DECISION ITEM: SECY-04-0102

TITLE: RESULTS OF THE STAFF'S EVALUATION OF POTENTIAL
DOSES TO THE PUBLIC FROM MATERIAL AT THE KISKI
VALLEY WATER POLLUTION CONTROL AUTHORITY SITE IN
LEECHBURG, PENNSYLVANIA

Commissioner McGaffigan's Comments on SECY-04-0102

Figure 2: Relationship between leachability-based distribution coefficient and pH for KVVWPCA ash (calculated using the final ratio method from results in ESSAP, 2004).

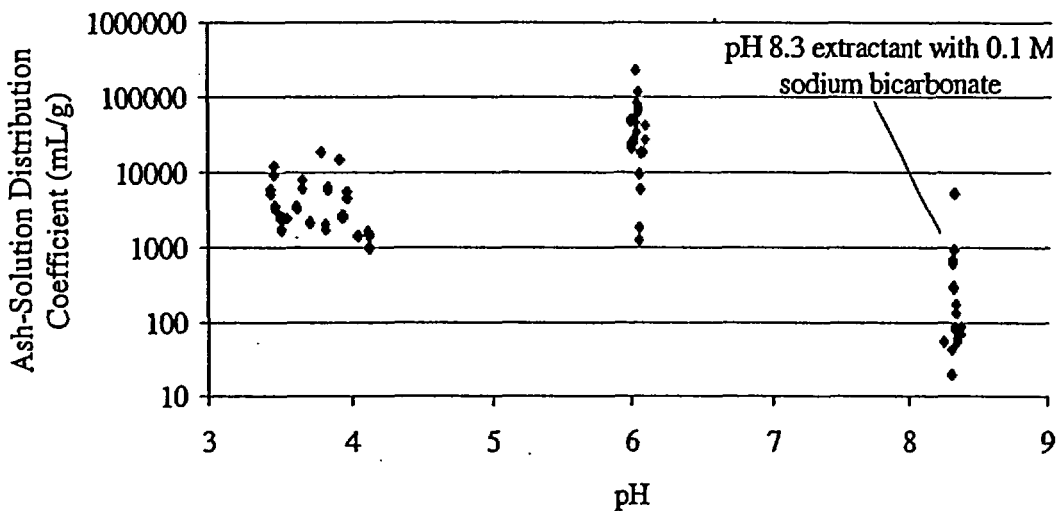
No sold

The extractions conducted at pH 8.3 were conducted with an extractant containing 0.1 M sodium bicarbonate which is expected to lower the calculated distribution coefficient significantly as compared to distribution coefficients calculated from the results of extractions performed without added carbonate species.
